## Apartment Design Guide Assessment Table

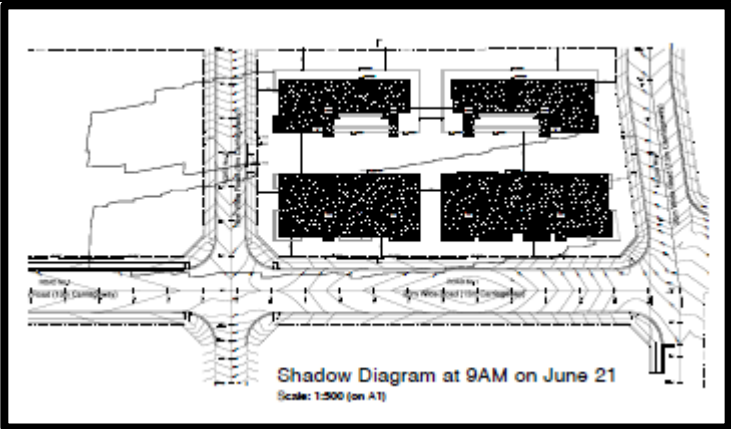
<p><u>3F-2 Visual Privacy</u></p> <p>Site and building design elements increase privacy without compromising access to light and air and balance outlook and views from habitable rooms and private open space</p>	<p>Visual privacy is compromised between balconies upon building A at the northern and southern ends of the building upon level 4, where balconies of adjoining units are separated by approximately 4.4 metres without adequate screening to retain privacy for individual units.</p>	<p>No</p>
<p><u>3G-1 Pedestrian Access and Entries</u></p> <p>Building entries and pedestrian access connects to and</p>	<p>The residential lift lobbies of the western building ( building B )</p>	<p>No</p>
